1992 Corvette: Service Bulletin: Hood Latch Striker Bolt

Subject: HOOD LATCH STRIKER BOLT (USE PAST MODEL SERVICE PARTS)

Model and Year: 1992 Corvettes, Prior to VIN Breakpoint N5100919

Bulletin Number: 92-43-10 - (11/07/1991)

VIEW A

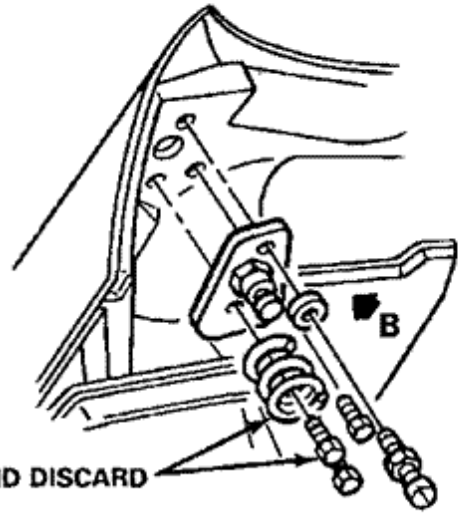
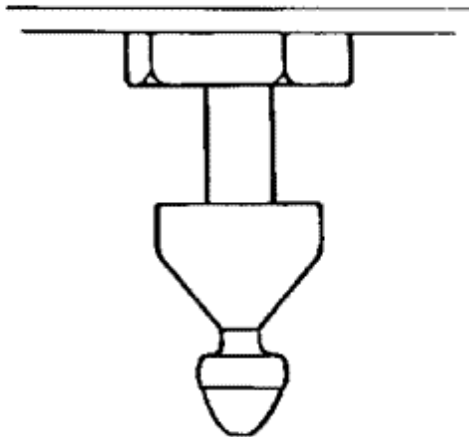
1. Raise hood to full open position. 2. Remove pop up spring and attaching bolt from bracket and discard (see View A). 3. Install new attaching bolt in position, tighten and torque to 27 N.m (20 lbs. ft.). 4. Loosen the locking nut on the striker latch bolt, remove bolt and nut from hood bracket, disassemble nut from bolt and save the nut for use on the new striker bolt. **DISCARD THE ORIGINAL STRIKER BOLT.** 5. Preassemble the new bolt, retainer, spring and original lock nut (see View B).

VIEW B — PRODUCTION

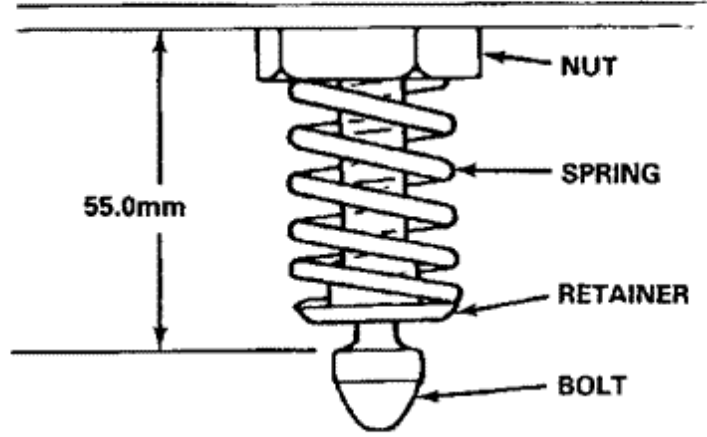
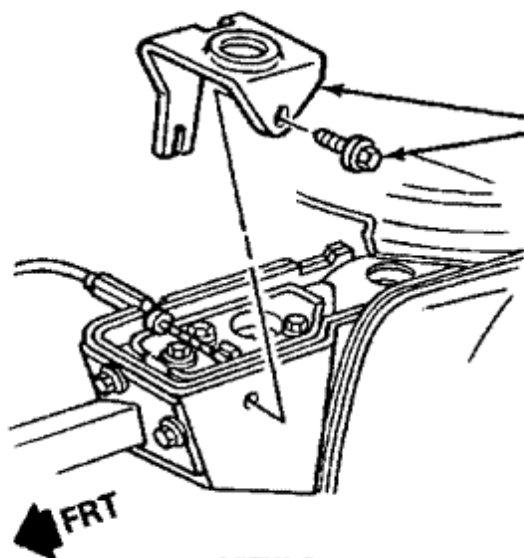
NOTE: The nut has a cavity on one side to act as spring seat.

6. Install the new striker bolt assembly to the bracket on hood, set initial

height as indicated on the illustration and tighten the locking nut. 7. Remove the outer attaching bolt for the spring seat (View C), loosen the inner attaching bolt and remove and discard the spring seat and outer attaching bolt. 8. Tighten the inner attaching bolt and torque to 25 N.m (18 lbs. ft.), see View C, inside View. 9. Carefully lower hood, check for latching and flushness conditions and adjust as required.
